OCEAN ISLE BEACH SHORELINE PROTECTION PROJECT
TERMINAL GROIN COMPONENT
ADDENDUM #1 – August 17th 2021

ADDENDUM #1 - ATTACHMENT 1 – Permit Drawings Plan Sheets 11 and 12 – Temporary Construction Trestle

OCEAN ISLE BEACH
SHORELINE PROTECTION PROJECT
TEMPORARY CONSTRUCTION TRESTLE PLAN VIEW

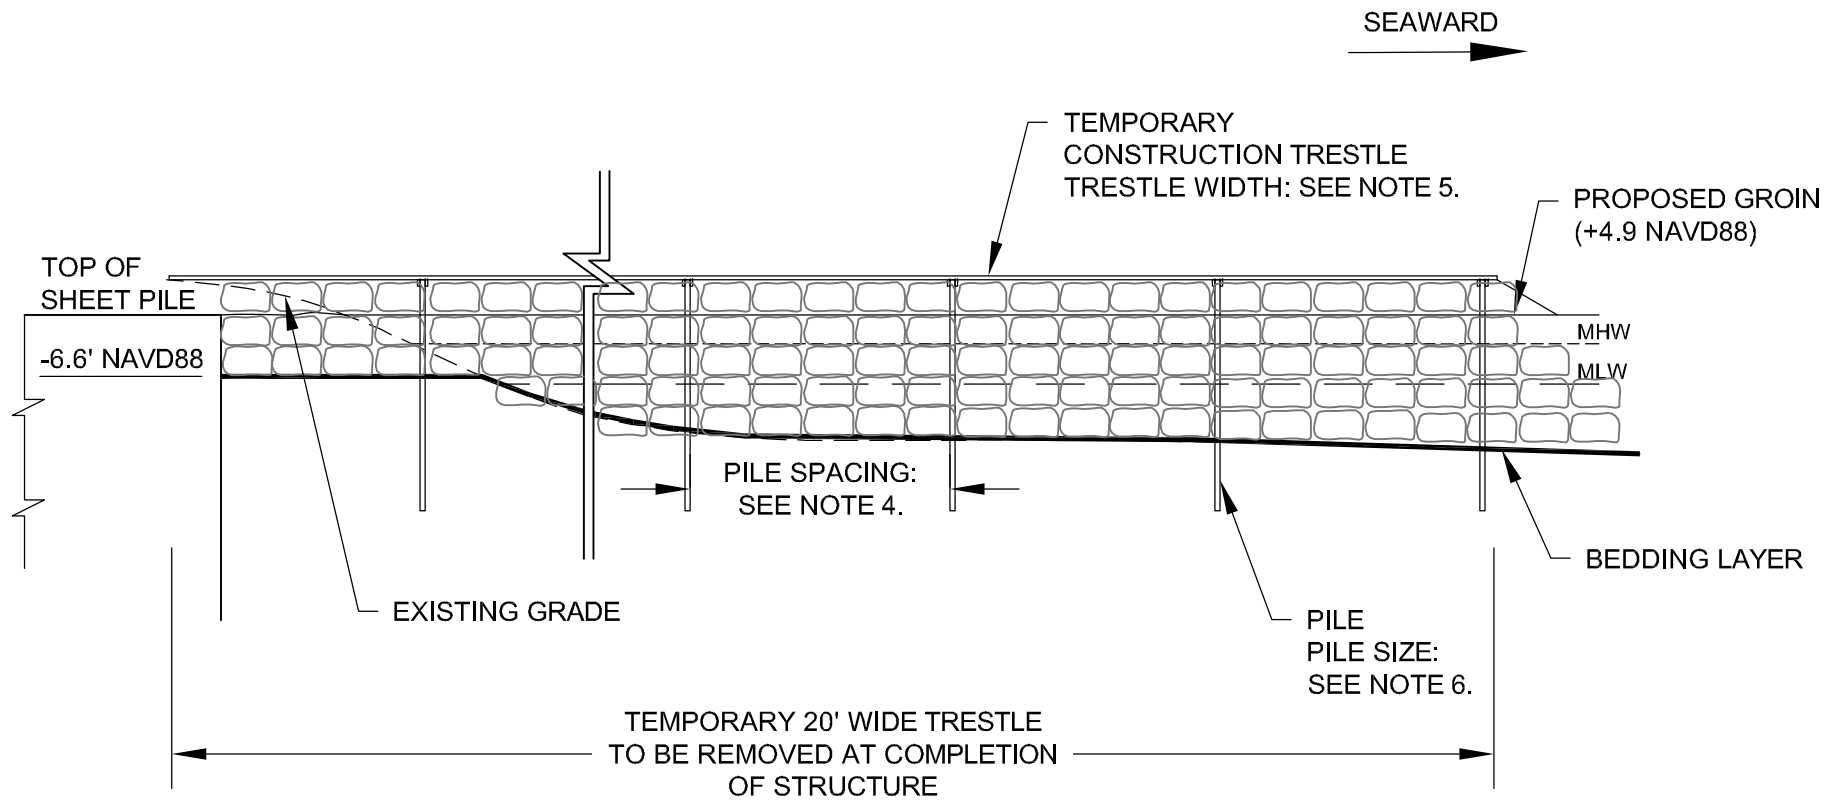
TECHNICAL PROVISIONS PART 01000, Section 20. Armor Stone Installation: *ADDED* the following section: “**20.9. Temporary Construction Trestle.** The permit for the project allows for a 20’ wide temporary trestle to be installed on either side and parallel to the alignment of the terminal groin. The temporary trestle shall be removed upon completion of the rubblemound portion of the terminal groin.” See the included attachment, Permit Drawings of the Temporary Construction Trestle.
